Serial No. 09/731617

Amendment dated February 5, 2004

Response to Office Action dated November 5, 2003

REMARKS/ARGUMENTS

FIG. 1

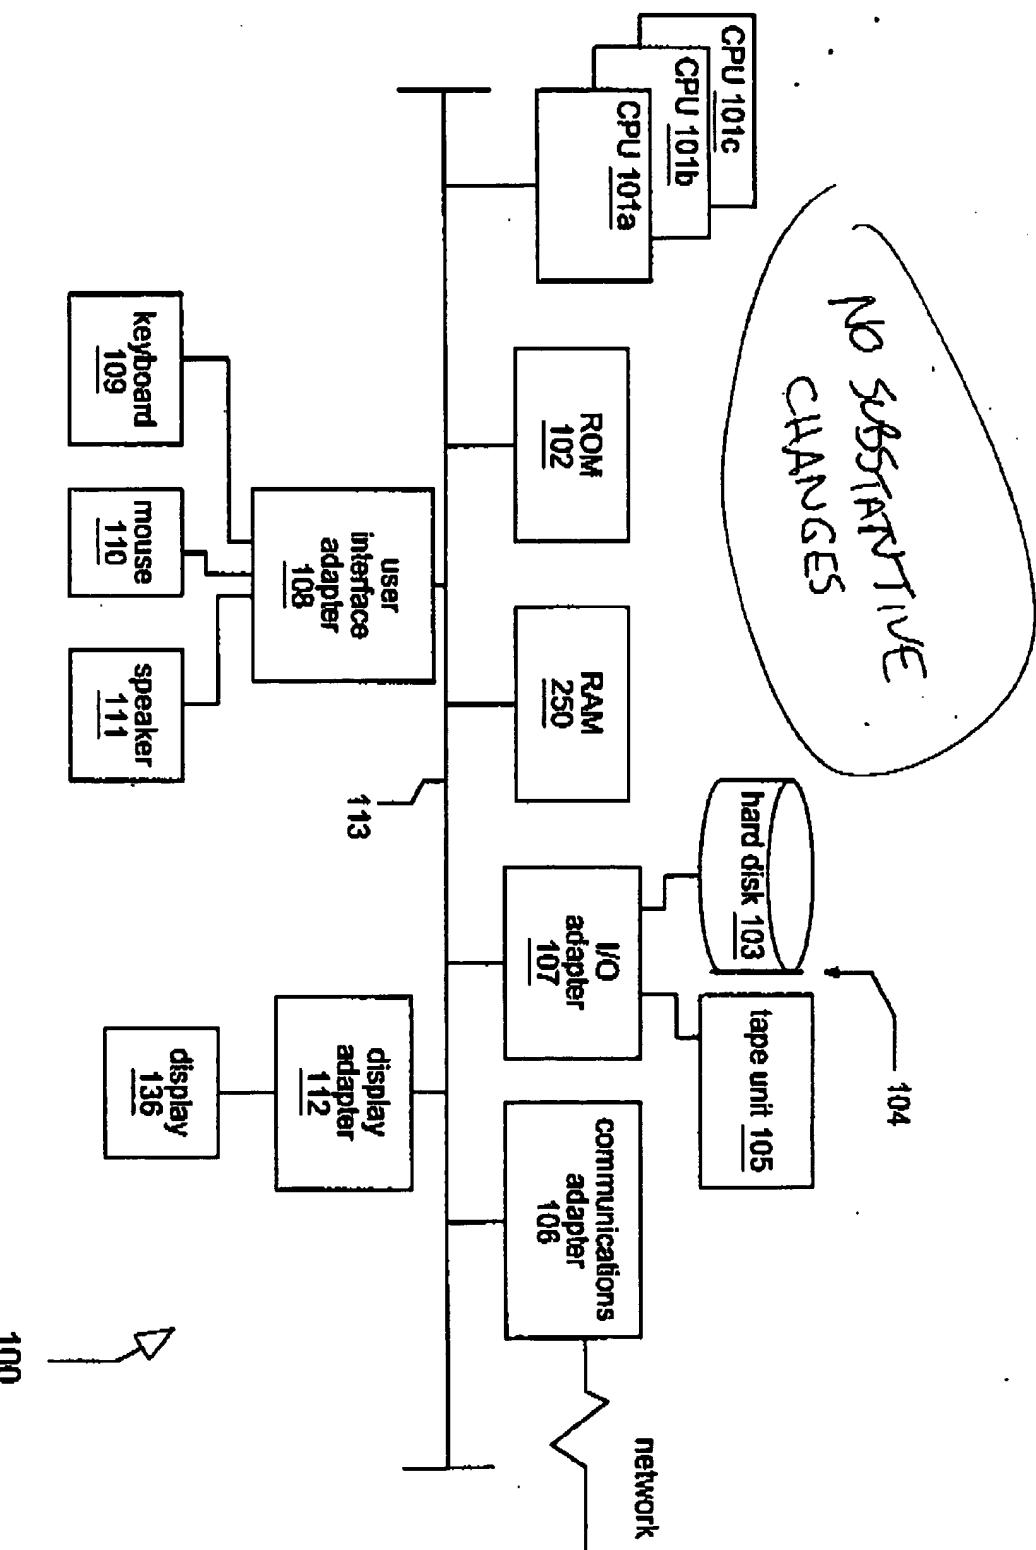
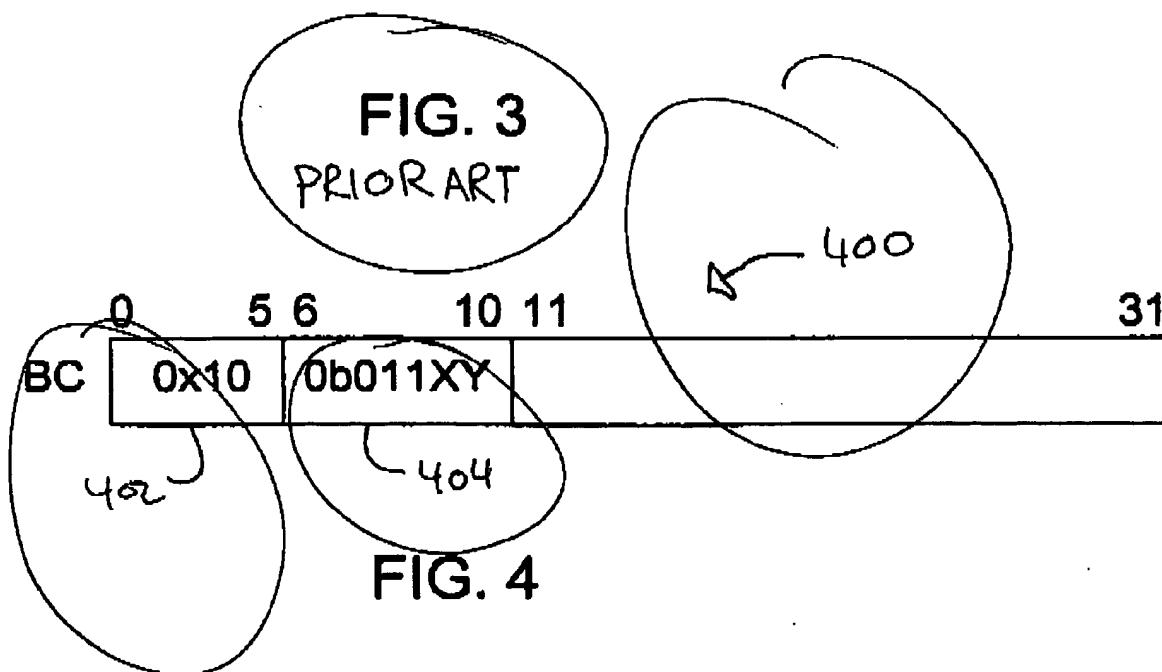
The Examiner also requested that a PRIOR ART designation be included on FIGs 1-3. Applicant has amended FIG 3 to include the PRIOR ART designation, but Applicant would respectfully submit that FIGs 1 and 2 do not depict prior art. FIG 5 illustrates selected details of a branch prediction unit 206 according to the present invention. FIG 2 illustrates selected elements of a microprocessor 101 that includes branch prediction unit 206. FIG 1 illustrates selected elements of a data processing system 100 that includes microprocessor 101. Thus, FIG 1 and FIG 2, both include the branch prediction unit that is illustrated in FIG 5 and therefore illustrate more than that which is old. Consistent with the requirement under 37 CFR 1.84(p)(4) requiring that reference numerals be used consistently throughout the different drawings, Applicant would respectfully submit that FIG 1 and FIG 2 are not prior art because they both include the novel branch prediction unit 206. Accordingly, Applicant requests the Examiner to reconsider and withdraw the objections to FIG 1 and FIG 2 and to withdraw the objections to FIG 3 and FIG 4 based on the proposed drawing amendments.
